METROPOLITAN GOVERNMENT OF NASHVILLE AND DAVIDSON COUNTY

STAFF RECOMMENDATION
1706-1708 Fourth Avenue North
October 15, 2014

Application: Demolition; New construction-infill
District: Salemtown Neighborhood Conservation Zoning Overlay
Council District: 19
Map and Parcel Number: 08205007300
Applicant: Britnie Turner and Jeremy Leggo, Aerial Development Group
Project Lead: Sean Alexander, sean.alexander@nashville.gov

1706 / 1708 4TH AVE
SITE PLAN

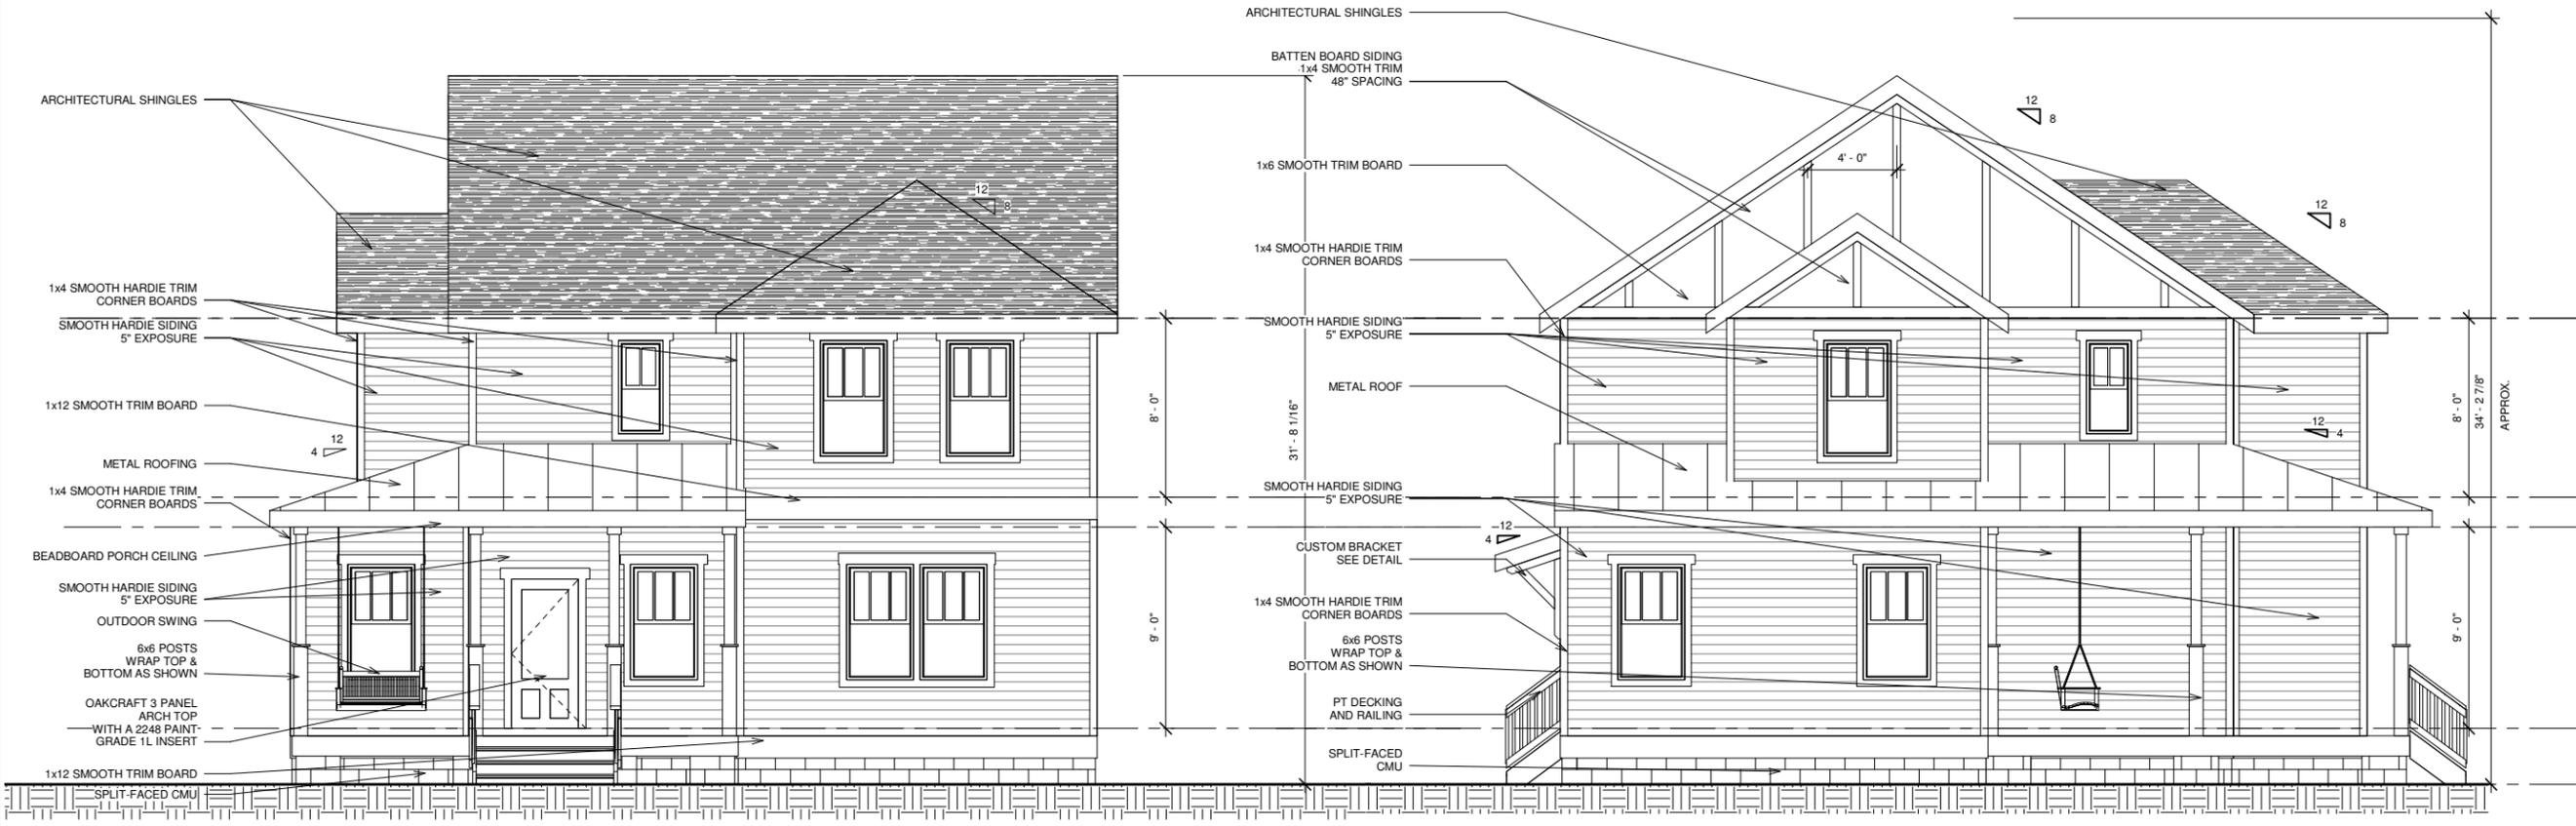
All six of the new buildings will be located five feet (5') from the outer sides of the property. The B and C buildings will face each other across a thirty foot (30') wide lawn at the center of the lot. Although accessory buildings often faced the side or to the rear, staff finds that this orientation for four buildings with the scale and character of the two-story houses is not appropriate.

Staff finds that the setbacks of the front buildings maintain the rhythm of spacing of the street, but that the rear buildings are not compatible with the setbacks and orientation of surrounding historic buildings. The project does not meet sections II.B.1.c, II.B.1.f, and II.B.1.k of the design guidelines.

1706A 4TH AVE ELEVATIONS

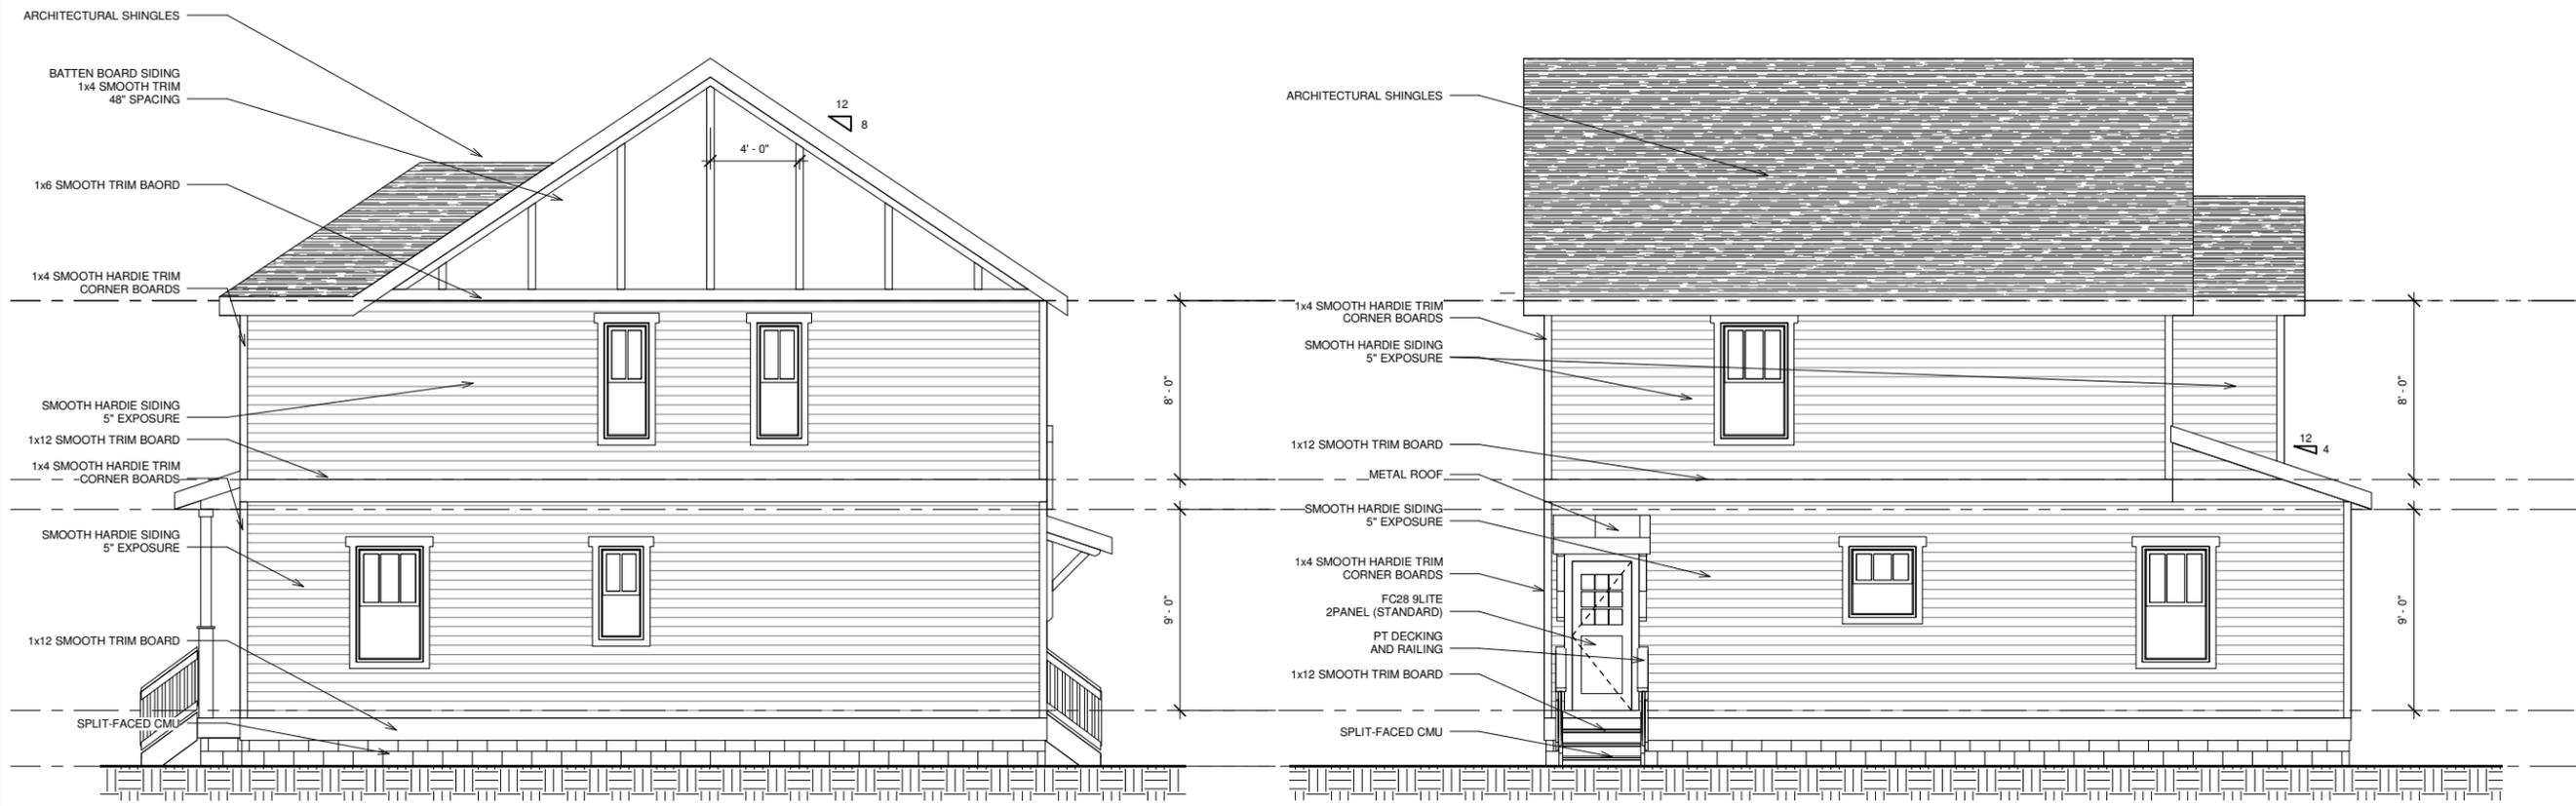
The two structures at the front of the lot, 1706A and 1708A on the plans, will have asymmetrical plans that mirror each other. They will be two stories tall with a square central mass and projections to the front and side. Both houses will have gabled roofs peaking at thirty-one feet, six inches (31'-6") above grade, with the roof of 1708A a front-facing gable and 1706A a side-facing gable. Included in these overall heights, both houses will have a floor level of approximately two feet, six inches (2'-6") above grade, with a porch roof height of ten feet (10') above the floor level and a primary eave height of eighteen feet (18') above floor level.

The front projections of these houses will be sixteen feet (16') wide, with the facade widening to twenty-eight feet (28') across the central mass and to thirty-six feet (36') at the widest point toward the rear. The footprint area of these houses will be roughly thirteen hundred square feet (1300 s.f.). This stepped asymmetrical configuration reduces the perceived scale of the house as it is seen from the street, and is compatible with the widths and form historic two-story Victorian houses.

Staff finds that the configuration of six two-story, single family homes on two lots is not in keeping with the character of the surrounding area and doesn't allow for a true courtyard, a key component of cottage or cluster developments. Although Staff finds the height and scale of the 1706A and 1708A houses to be appropriate, the rear units are not sufficiently subordinate to the front units. Staff finds that the project does not meet guidelines II.B.1.a. and b.
